of a request to Kaipara District Council for
Private Plan Change 81: Dargaville
Racecourse by the Dargaville Racing Club Inc

STATEMENT OF EVIDENCE OF HENDRIK (HENK) DE WET ON BEHALF OF THE APPLICANT

CIVIL ENGINEERING – 3 WATERS

10 MARCH 2023

Figure 1 – Lands and Survey Engineering 2D Hydraulic model of overland flow

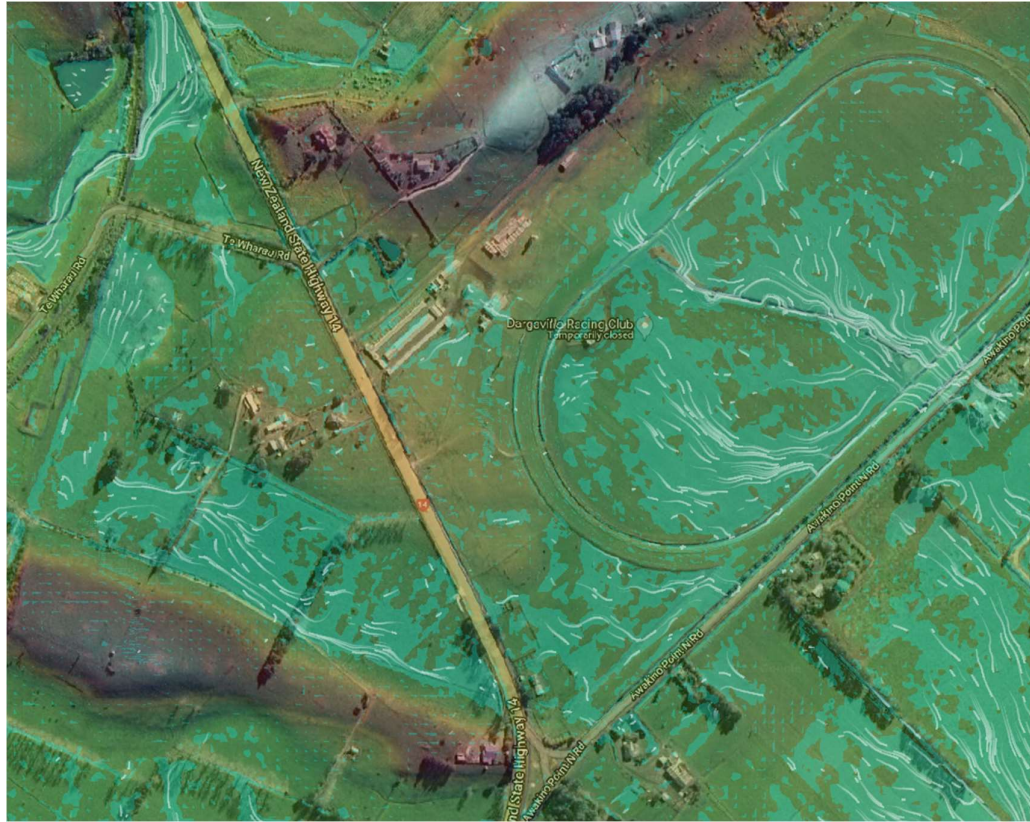
- 6.4 I understand from correspondence between Waka Kotahi and KDC subsequent to the 42A report that Waka Kotahi agrees with a comment in the AWA report titled *Initial Review of Stormwater Management for Private Plan Change 81, included in the 42A report that “Further information is required regarding the effects of stormwater discharges from the development on the State Highway drain system and the pavement/corridor”.*

- 6.5 I reviewed this during my assessment of overland flow and drainage and confirm that it will be unlikely that there will be any effects on the State Highway drainage system. The section of State Highway along the western boundary of the site drains in a north-western direction, whereas the site drains in a south-eastern direction. Therefore, no discharge from the site is expected to be towards the State Highway.
